From: [Ed Castle <edrcastle@me.com>](mailto:edrcastle@me.com)
To: [Chris Johnson<chris@kwru.com>](mailto:Chris.Johnson@kwru.com)
[Greg Wright<greg@kwru.com>](mailto:Greg.Wright@kwru.com)
Date: 3/23/2018 1:25:29 PM
Subject: New Generator Layout

**GENERATOR DETAILS
FOR
KWRU WWTP EXPANSION**

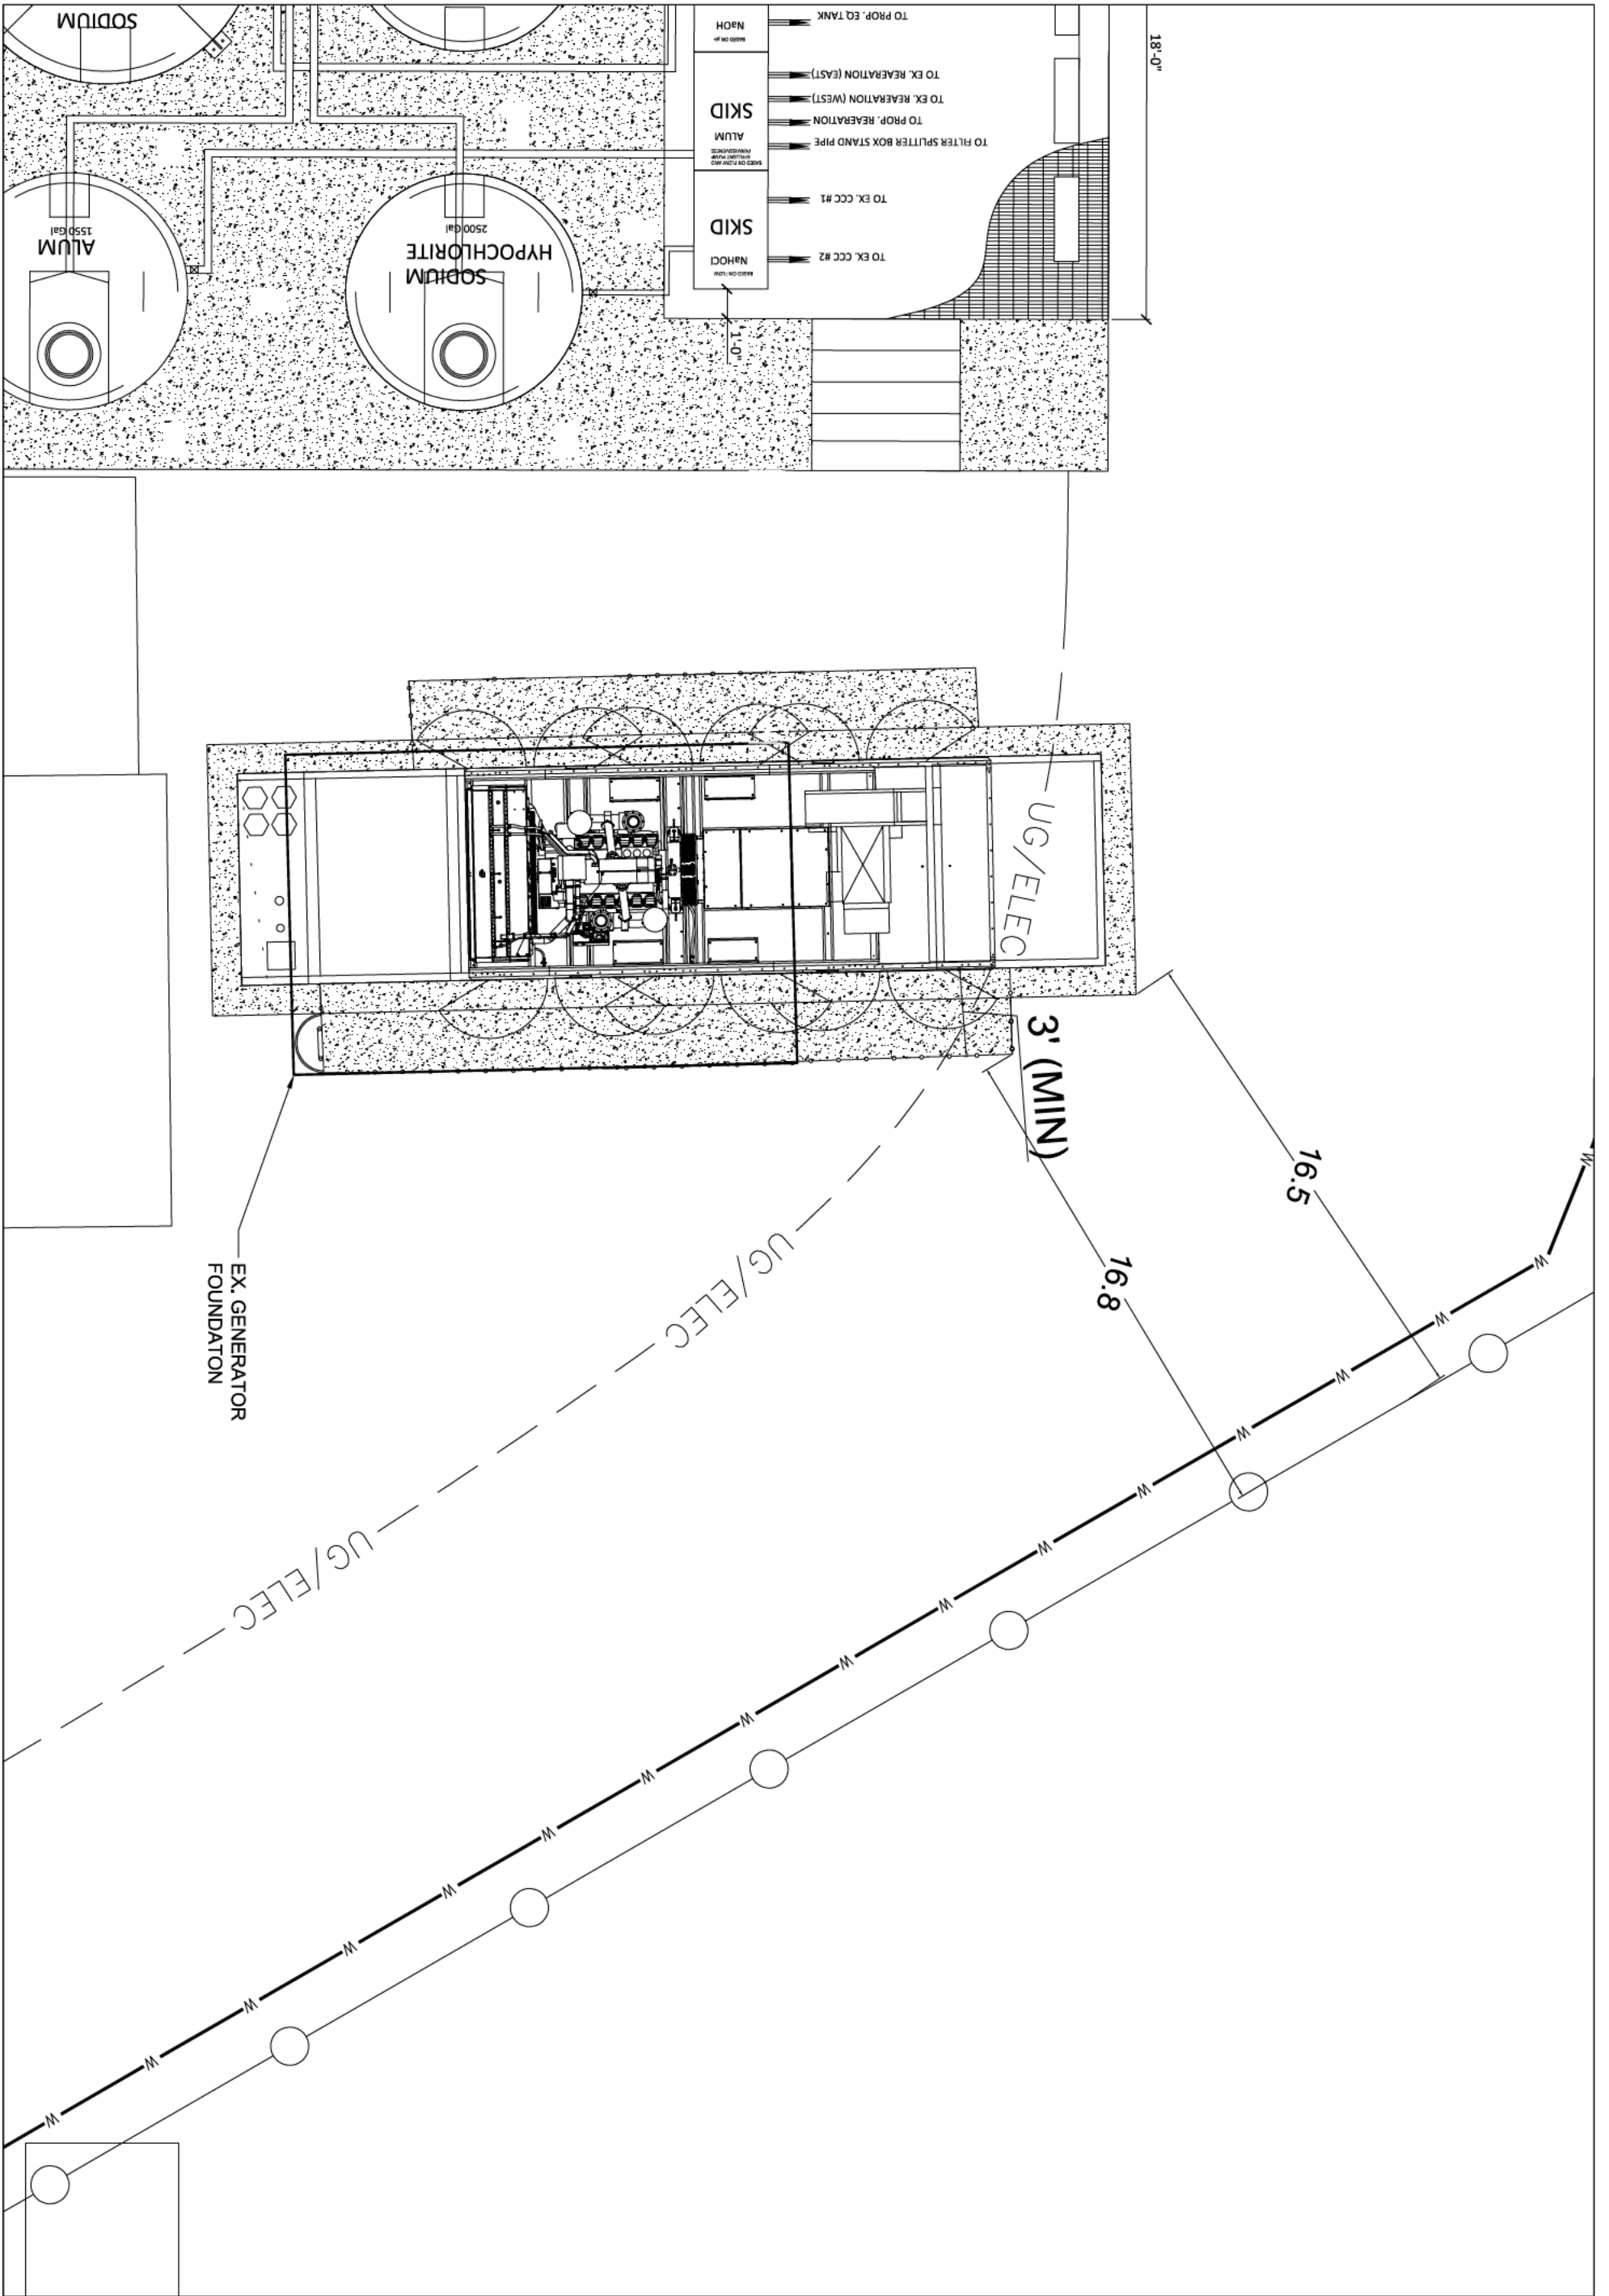
Is this what you had in mind? I think we could shorten the access walkway on the right side where the ladder is shown. Make it match the one on the chemical slab side.

There will be a little bit of the old foundation sticking out on that one corner, but if I slide the new foundation to the east so the narrow part lines up with the old slab, we will have more of a pinch point along the fence.

Let me know if you want this changed or if it is OK.
